February 2021 | Danfoss Cooling & Sensing Solutions

TECH INSIDER

Packaging label today   **Packaging label going forward**

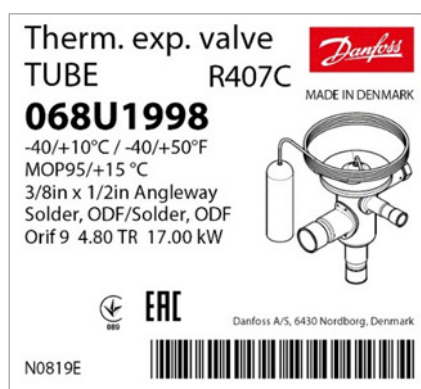
Description
The UL approval marking will be added to the valves in 2nd week of 2021.
Laser engraving of the top of the valve types TUA, TUAE, TUB, TUBE, TUC, TUCE, TCAE, TCBE and TCCE for normal pressure refrigerants will be changed as follows:

The factory set value will be removed from the valves. Reason is that if the customer changes the setting during installation, this value is no longer correct.
Instead of having the factory set value on the valve in the laser engraving, it will be moved to the external packaging label. This way, the set information will be correct as the valve is received, but customer can change the setting without ending up with contradicting information on the product.

No change to the valves' form, fit and function. Maximum Working Pressure (MWP) will remain unchanged.
Apart from the added UL marking, the only change is that the previously engraved factory set value has been removed and moved to the packaging label.
